Application for an Individual Section 401 Water Quality Certification, Individual Section 404 Permit and CAMA Major Permit for the construction of US 158 from the Murfreesboro Bypass to US 13 west of Winton, Hertford County, TIP No. R-2583, State Project No. 6.079007T

Meeting Name: R-2583 (Design-Build) CP 4C Permit Drawing Review Meeting

HERTFORD COUNTY
PROJECT: 35489.3.1 R-2583

SITE 2

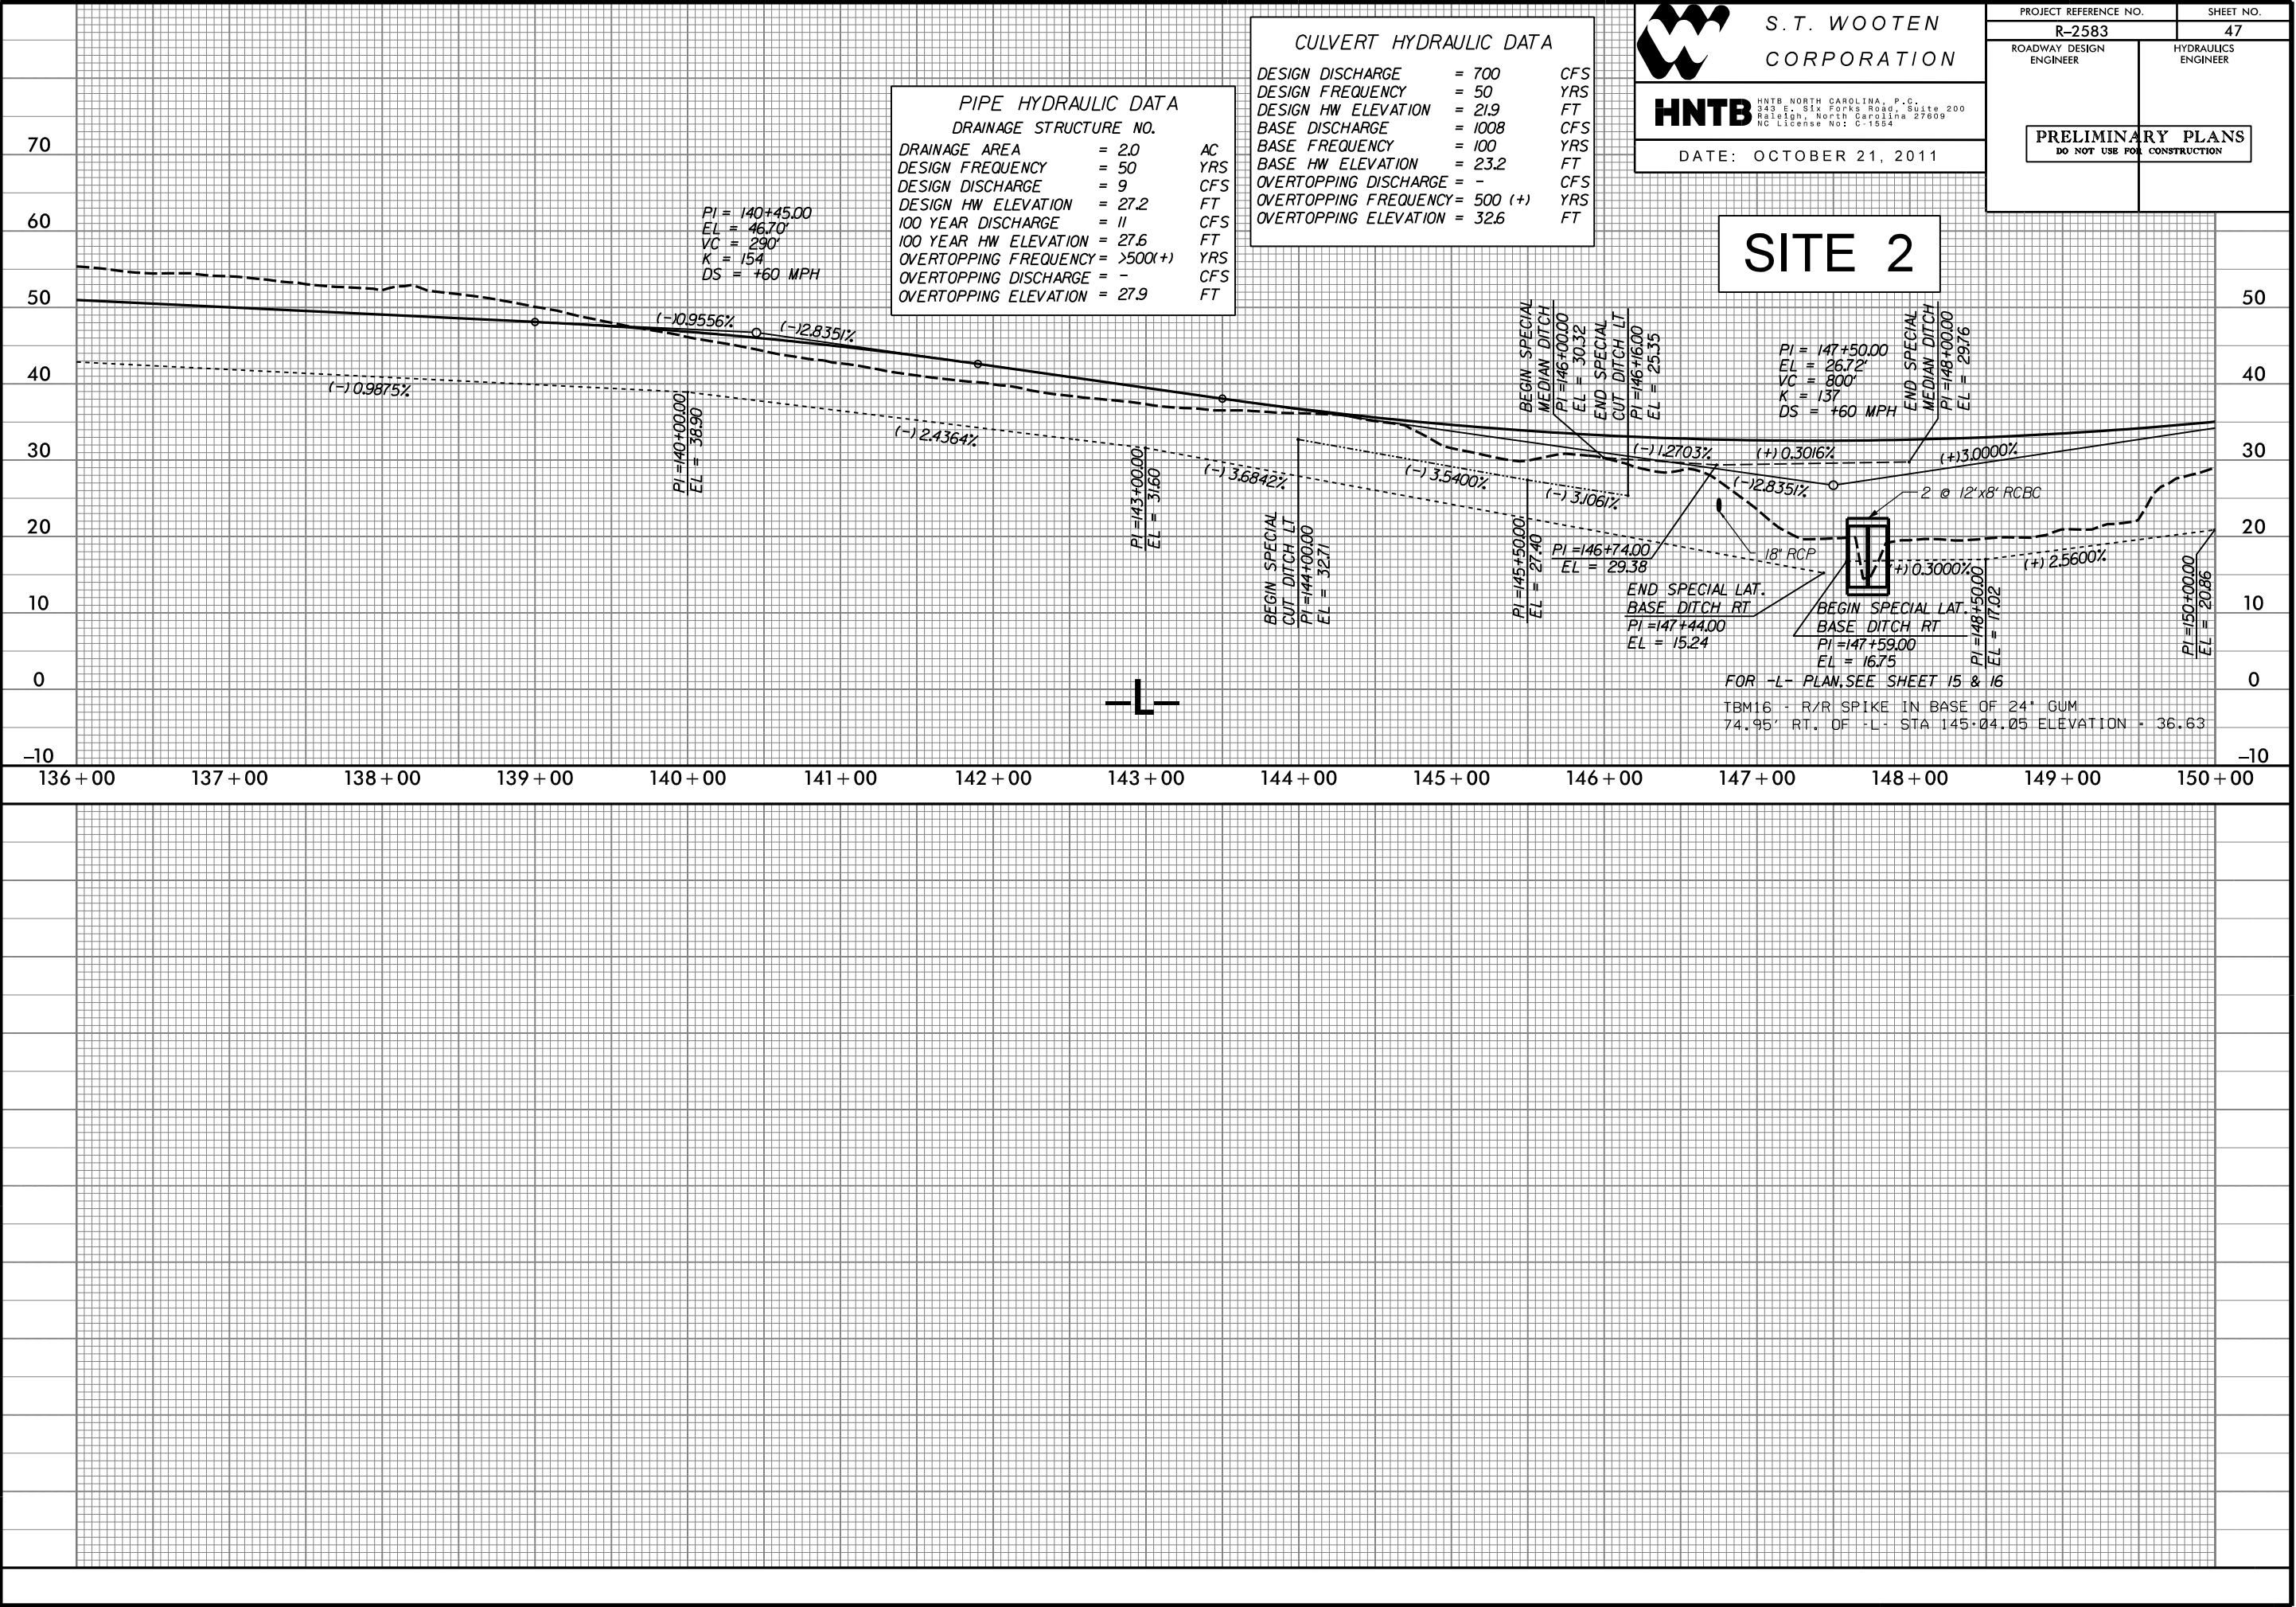
- **Site 1**
 - Mr. Rogers discussed how lateral ditches that drain toward wetlands will be tapered down to zero depth in order to diffuse flow before entering the wetlands. In addition, swale outlet data has been provided on the permit drawings. The same general approach is being used at multiple sites. There were no questions for this site.

SITE 10

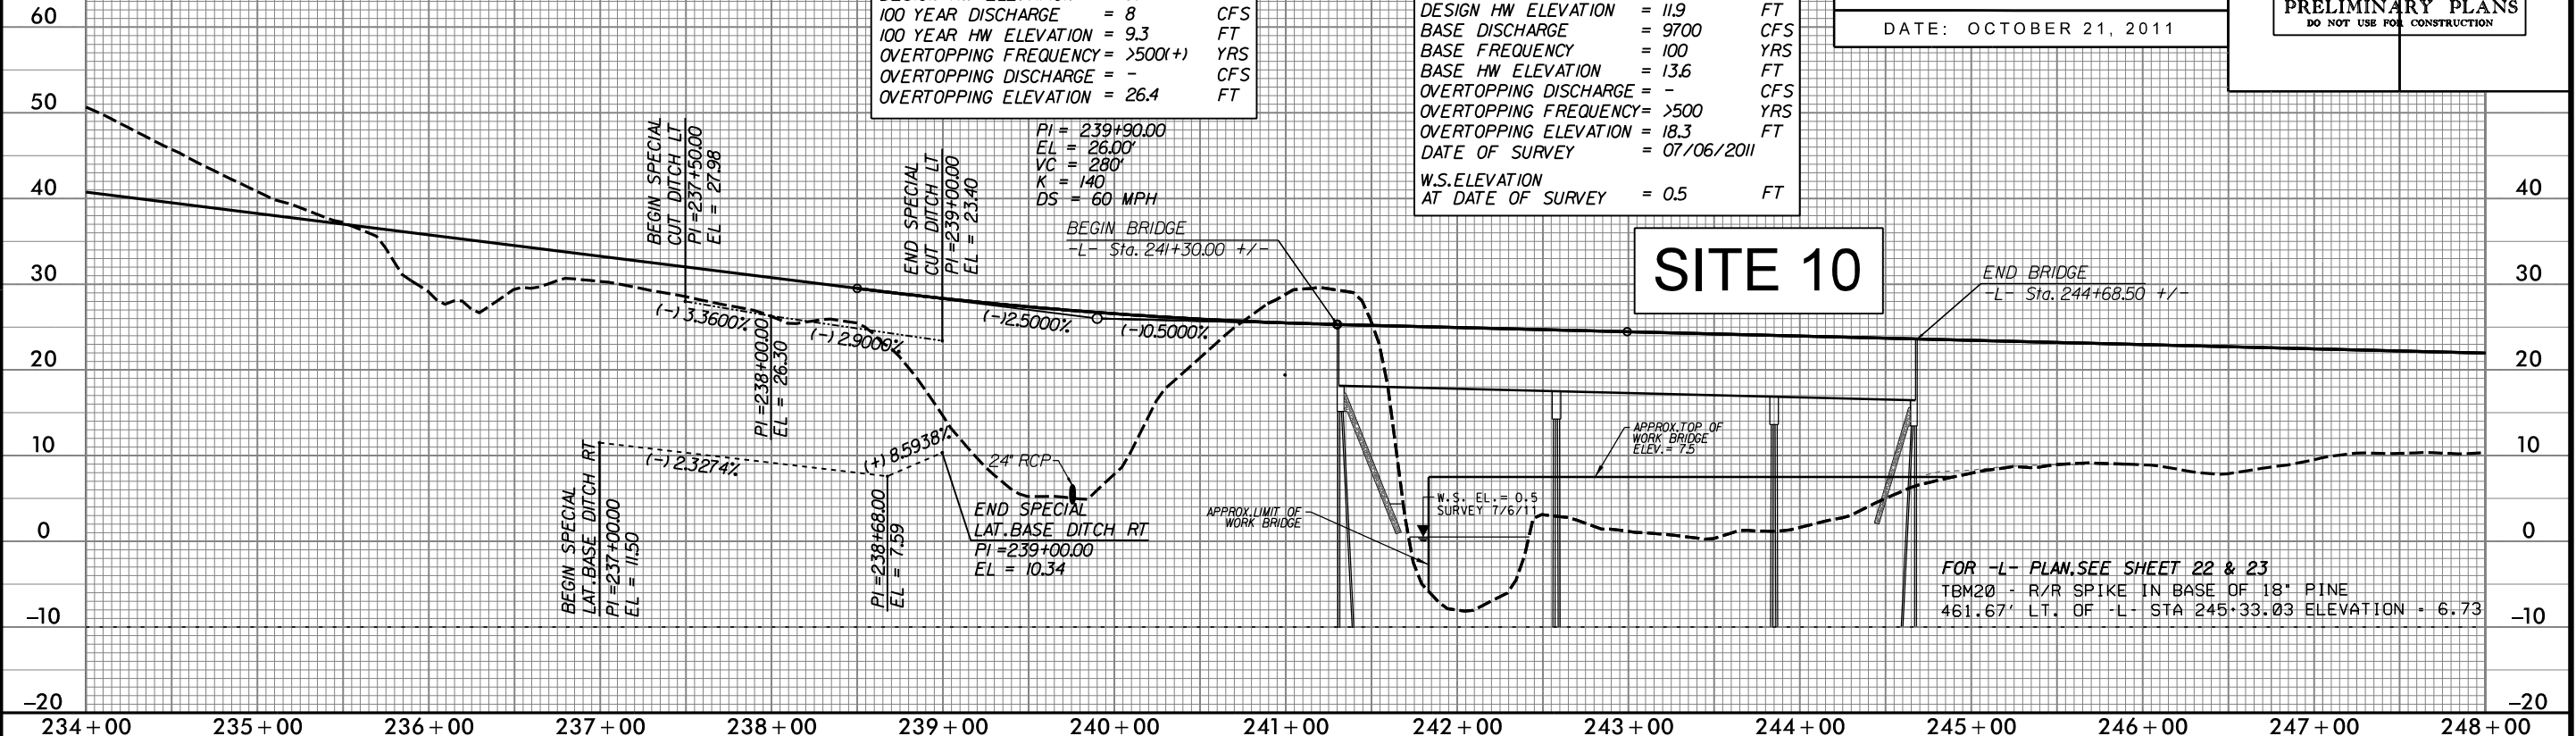
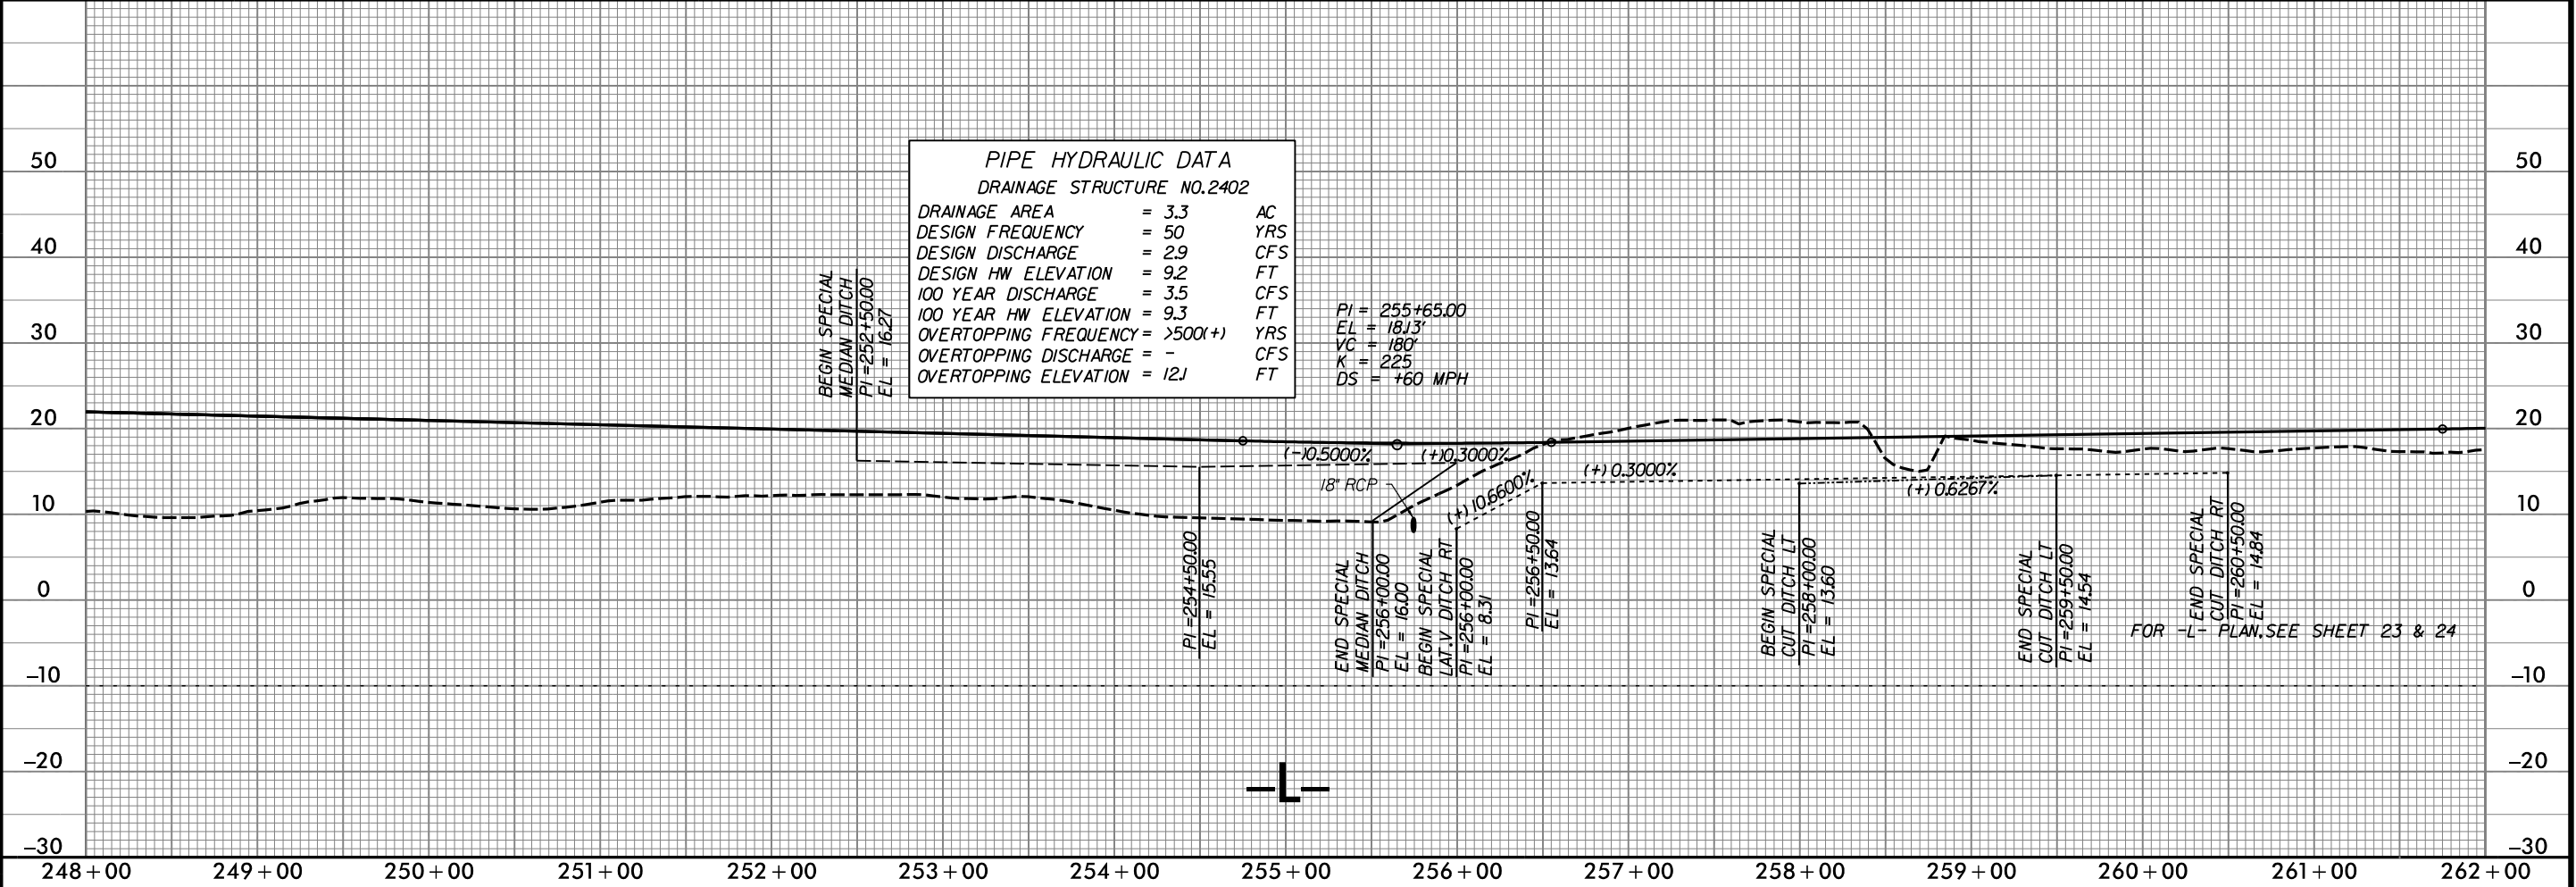
- **Site 10**
 - An inquiry was made regarding the temporary work bridge vertical clearance. It was also stated that The D-B team should coordinate with DCM concerning minimum horizontal and vertical clearance since Potecasi Creek is often used for canoeing. Mr. Rogers stated that the approximate work bridge elevation currently noted on the roadway profile sheet is 7.5'. Mr. Bivens stated that the work bridge design has not been finalized and that the D-B team will work to accommodate the required horizontal and vertical clearances.

- Mr. Capehart stated that the limits of hand clearing off the proposed bridges does not look sufficient. The current hand clearing limits are offset at 10'. The D-B team agreed with this comment and will revise the hand clearing offset to 30'.
